**Subject:** Final Status Report for Decommissioning  
Control Number: 137512

**Re:** West Virginia University Institute of Technology  
NRC License No. SNM-1990, Docket 07003071

### **Additional Information**

## RADIATION SAFETY SURVEY

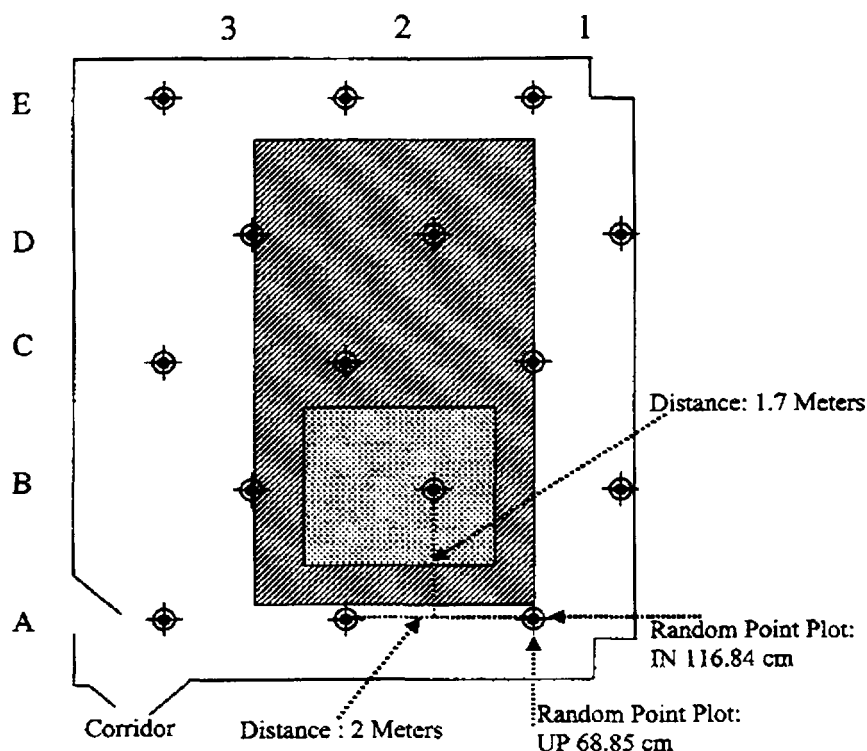
- b. Specify the calculations and the instrument efficiency that was used to determine the results of the static measurements in the "Radiation Safety Survey"; using the efficiency of 0.12 stated in Table 10, we cannot replicate the results.

*A corrected report is attached. All results remain less than the DCGL. Attachment 2*
